ENGINEERING CHANGE NOTIFICATION

MTK PWR 4.2 - 10134170 Receptacle
Crimp Terminal

07-02-2024

Product: MTK PWR 4.2 Rec Crimp terminal (16AWG) - 10134170-XX10LF

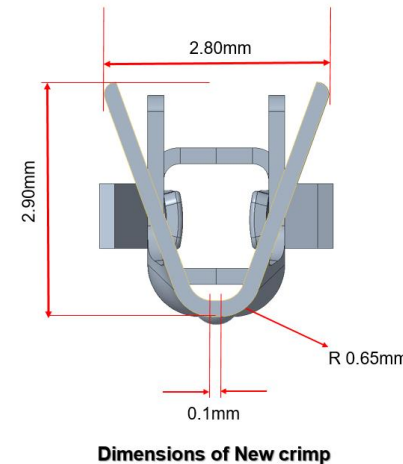
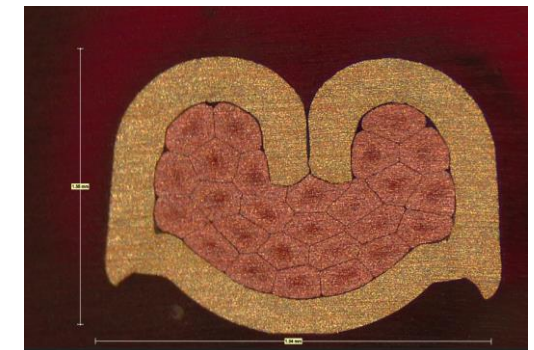
BEFORE

AFTER

REASON FOR CHANGE

Product improvement to be aligned with the requirement specified in IEC60352-2 Edition 3.0 standard.

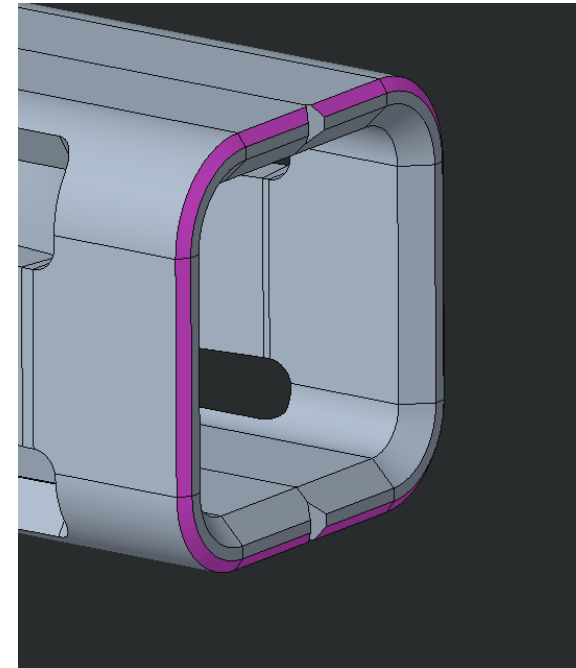
BEFORE

- ✓ Only Chamfer on inside edge provided.

AFTER

- ✓ Along with inside chamfer, minor chamfer on outside edge provided.

REASON FOR CHANGE

To prevent the plastic material shaving during terminals insertion into housing
